LIGO HANFORD OBSERVATORY (LHO)  
 CORNER STATION (SHEET 1)

LIGO LIVINGSTON OBSERVATORY (LLO) CORNER STATION (SHEET 2)

MID- AND END-STATION VEAS AT BOTH OBSERVATORIES (SHEET 3)

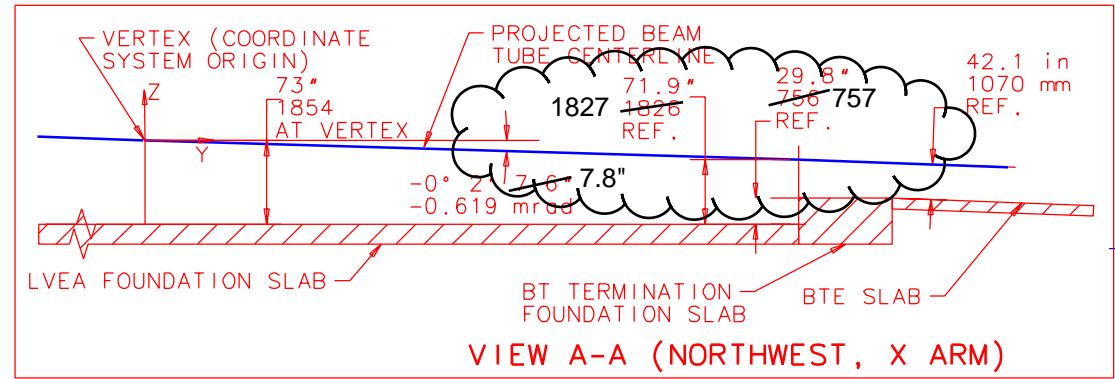
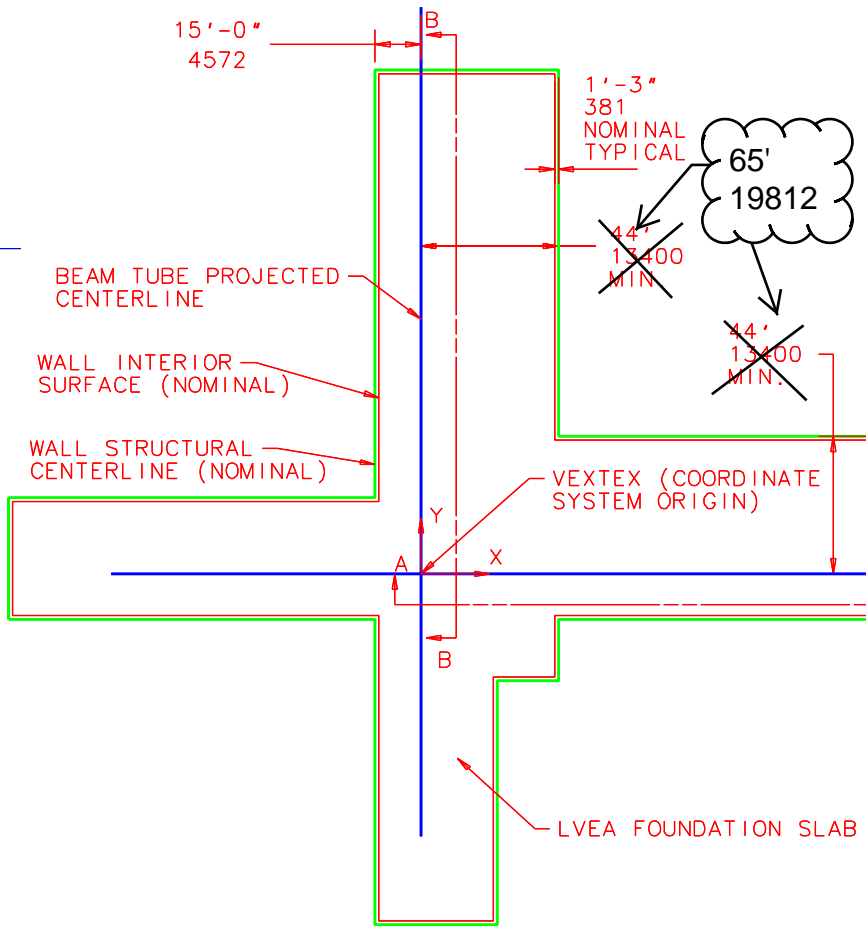
CHANGE DIRECTION  
 (SLOPE UP, NOT DOWN)

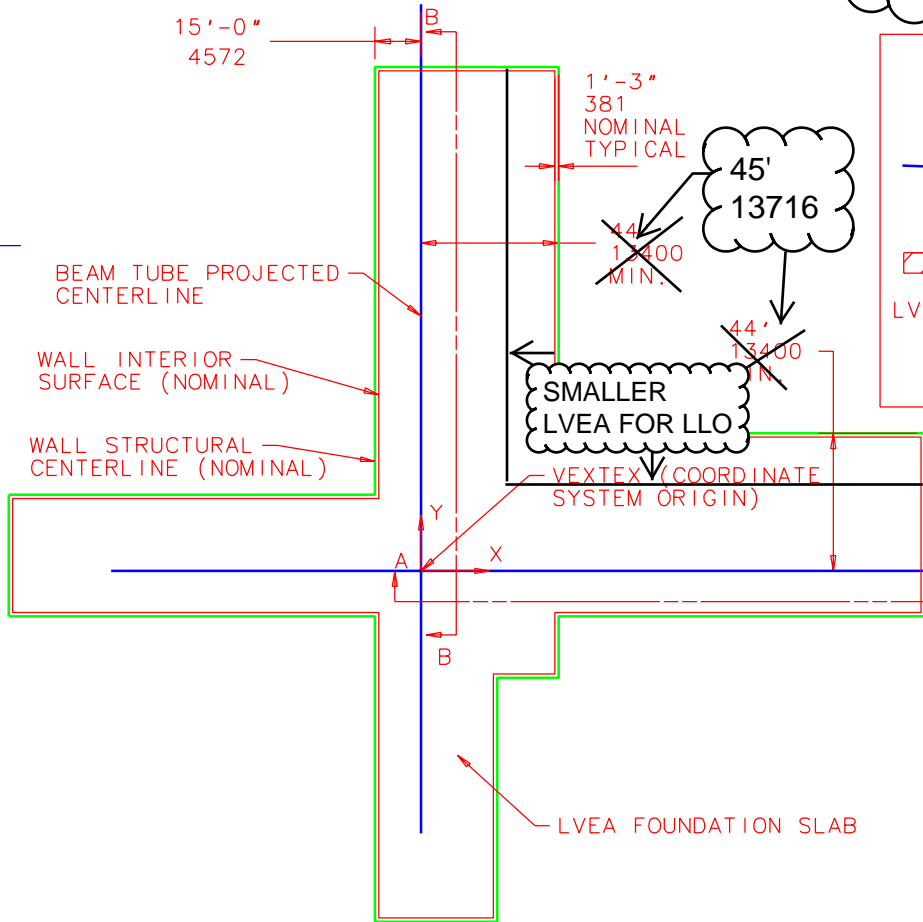
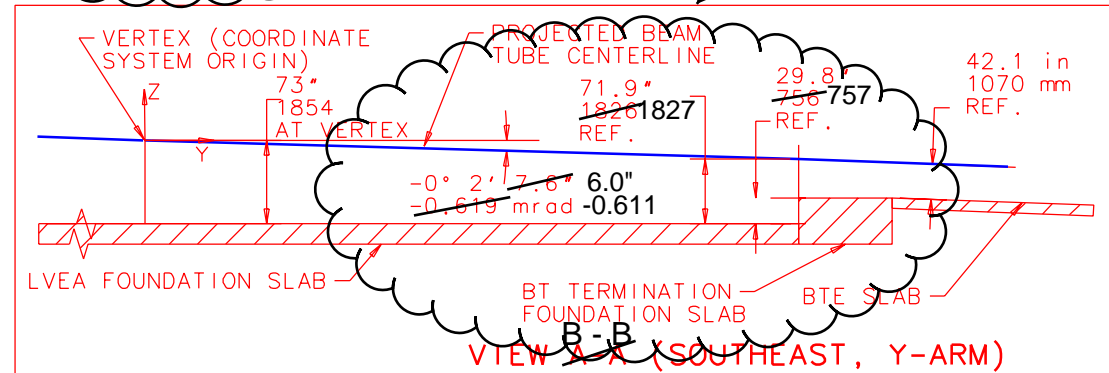
SWAP POSITIONS OF A-A & B-B VIEWS TO BE CONSISTENT WITH LHO DRAWING

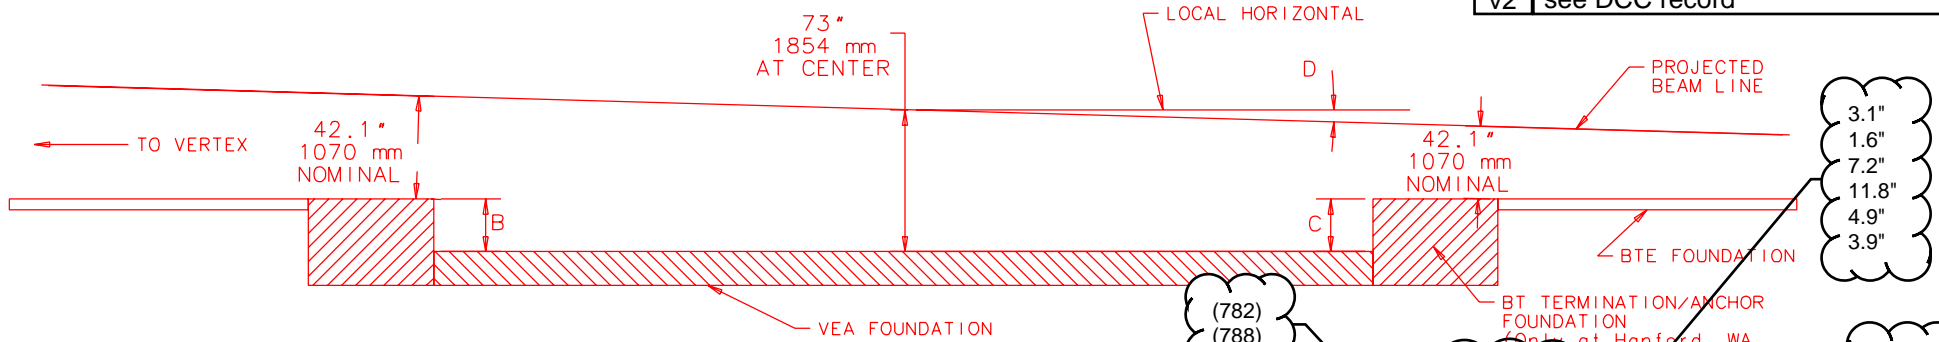
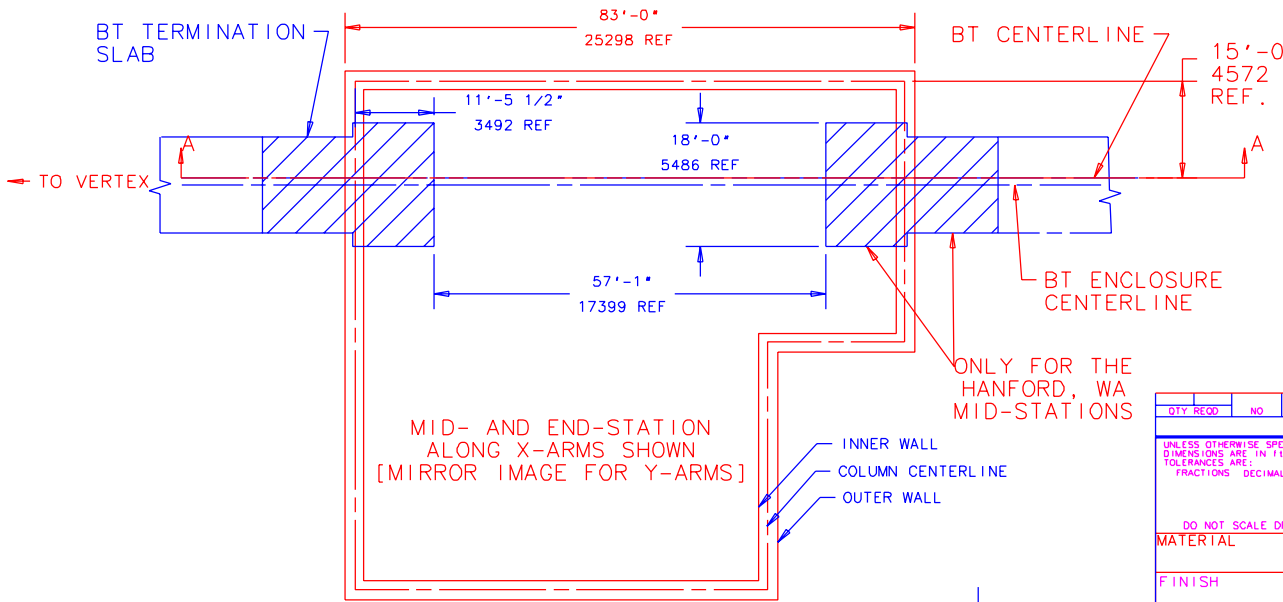
(788)  
 (785)  
 (782)  
 (779)  
 (782)  
 (785)

3.1"  
 1.6"  
 7.2"  
 11.8"  
 4.9"  
 3.9"

-0.306  
 0.008  
 0.326  
 0.639  
 0.315  
 0.019
